MILITARY SPECIFICATION

DISPENSER ASSEMBLY

This amendment forms a part of Military Specification MIL-D-63123A(AR), dated 17 December, 1979, and is approved for use by the US Army Armament Research and Development Command and is available for use by all the Departments and Agencies of the Department of Defense.

FIGURE 1 Dispense pulse

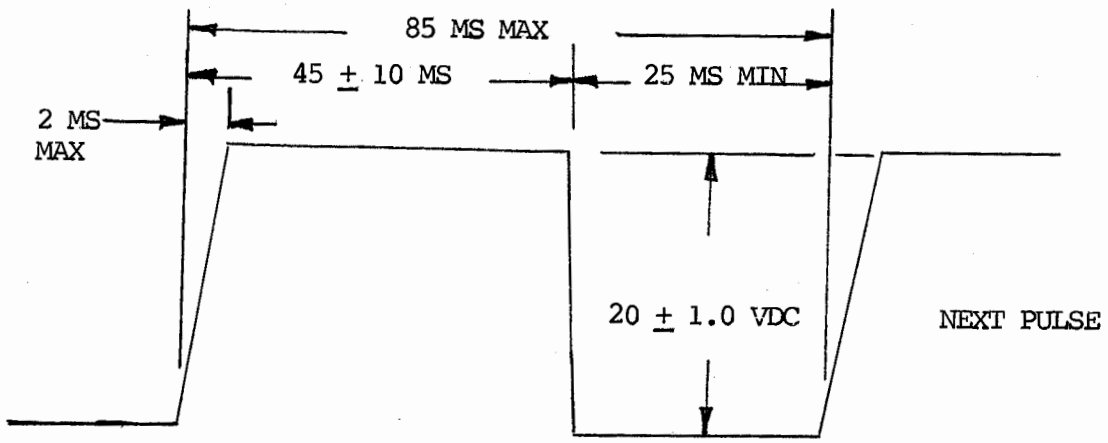
3.3.1, Change to read:

Add "Figure 1" as shown:

"The dispenser assembly, in both the chaff and flare modes upon receipt of thirty (30) pulses of 20 to 30 volt direct current (DC) dispense pulses conforming to Figure 1, shall fire 30 payloads in sequence, 1 through 30".
